DART AEROSPACE LTD	Work Order:	22998
Description: Backing plate	Part Number:	D2228
Drawing: D2228 rev.A	Qty:	160 209

DRAWN BRADLEY 94.3.23		DART AERO ACCESSORIES INC VICTORIA INTERNATIONAL AIRPORT, CANADA	
DESIGN BRADLEY 94.3.23	DRAWING NO. D2228	REV. B	
STRESS	TITLE BACKING PLATE		
B	00.09.11	UPDATE FINISH SPEC. #4

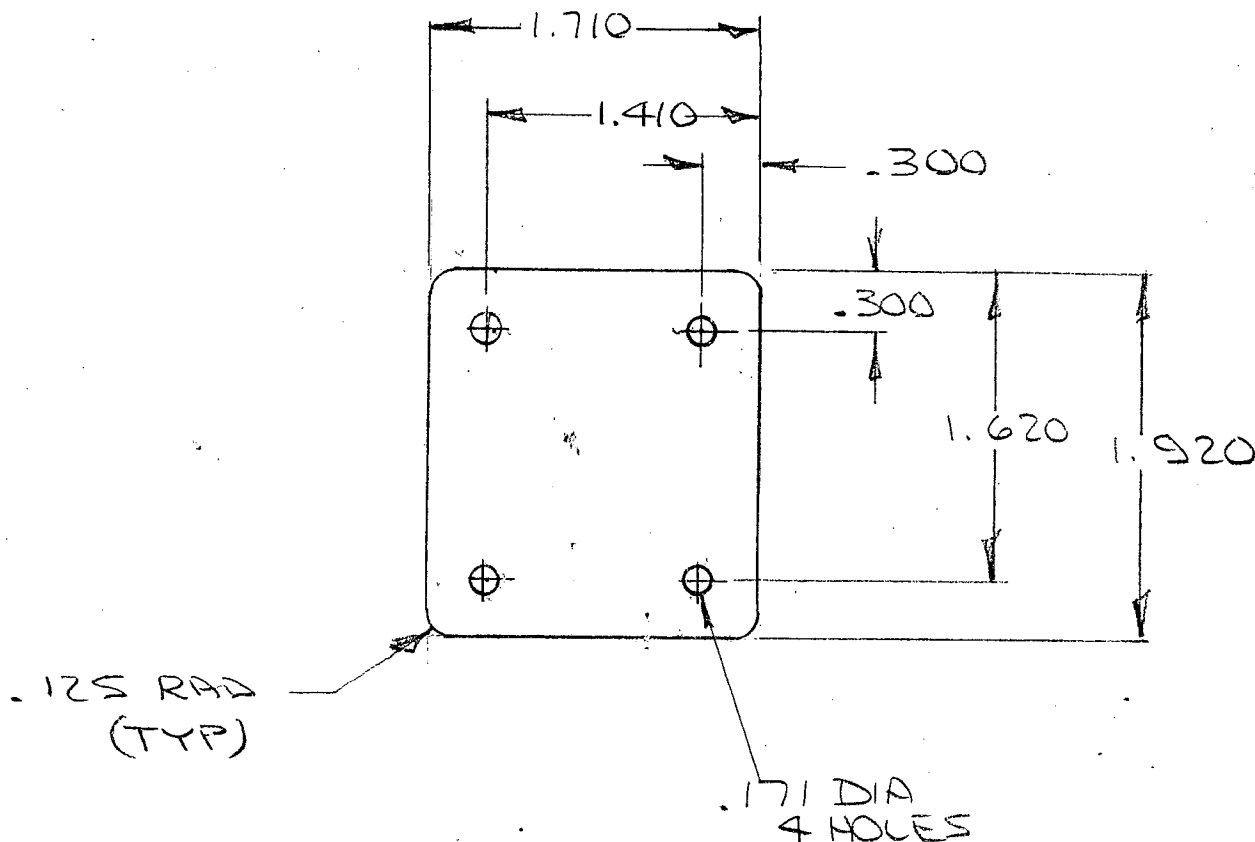
NCR:		WORK ORDER NON-CONFORMANCE (NCR)						
DATE	STEP	Description of NC Section A	Corrective Action Section B			Verification Section C	Approval Design Mgr	Approval QC Inspector
			Initial Design Mgr	Action Description Design Mgr	Sign & Date			
05-06-02	2	Hole distance no good on 10 parts <u>10 others parts</u> Holes deburr to deep	 05-06-02	Scrap and replace <u>20 parts</u>	 05-09-12	 05-08-12	 05-08-02	 05-08-02
05/09/14	3	Mist the Hole Scrap 2 piece	 05-09-14	No replaces	 05/09/14	 05-09-14	 05-09-14	 05-09-14
05-09-14	4	Holes are .015" over the dimensions.	 05-09-14	Parts are acceptable.		 05-09-14	 05-09-14	 05-09-14
